NRND (Not Recommended for New Designs) Letter

[PN LSP69001299TR]

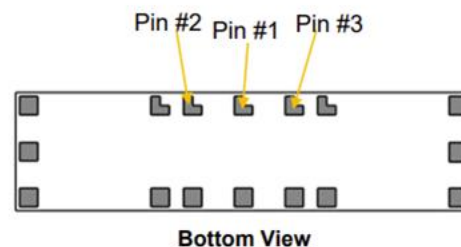
The new P622301 antenna has the same size and compatible RF performance with LSP69001299TR. The main difference is on the bottom side. Both PNs have the same electrical (RF feed and ground) pins. The additional pins on P622301 are mechanical ones to have more soldering pads, making the design more robust for the roughest conditions.

Pin	LSP69001299TR	P622301
RF Feed	Pin 4	Pin 1
Tuning pad 1	Pin 3	Pin 2
Tuning pad 2	Pin 5	Pin 3
Soldering pad for only mechanical purpose	All other Pins	All other Pins
